D3016-041 SEAT FRAME ASSEMBLY

DRAWING NO. D3016	TITLE SEAT FRAME ASSEMBLY	REV. A	DART AEROSPACE LTD ENGINEERING ORDER	D.E.O. NO. D3016-A-1	SHEET NO. SHEET 1 OF 1	SCALE NTS
DRAWN <i>1</i>	CHECKED <i>UP</i>	MFG. APPR. <i>RE</i>	APPROVED <i>MP</i>	DE APPR. <i>TH</i>		
DATE 10.01.29	DATE 10.01.29	DATE 10.01.29	DATE 10.01.29	DATE 10.01.29

TO REVISE D3016-11 SADDLE'S HOLE SIZES

D3016-11 SADDLE

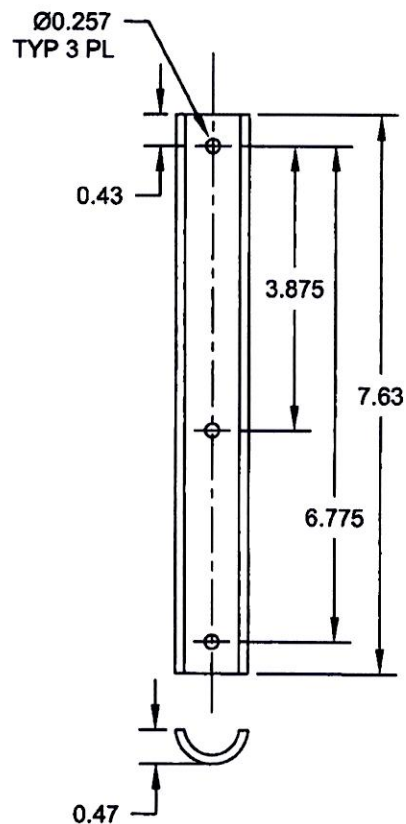
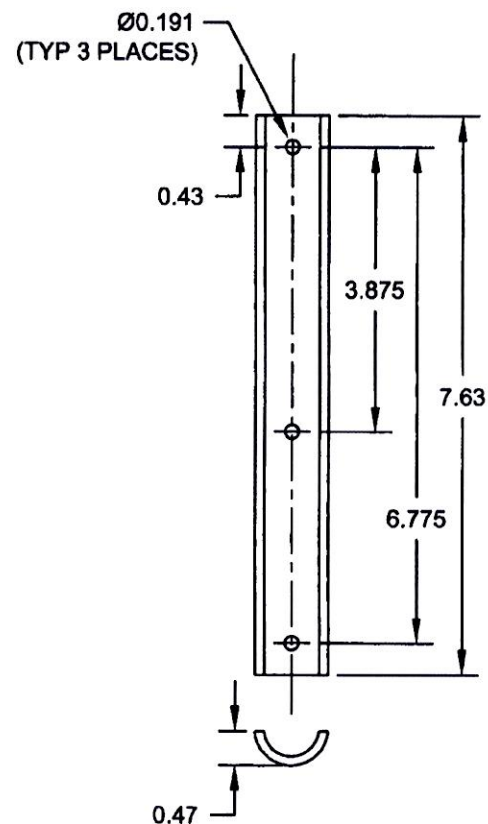
DETAIL D3016-11 SADDLE (SHEET 3): Ø0.257 TYP 3 PL WAS Ø0.191 (TYP 3 PLACES) AS SHOWN:
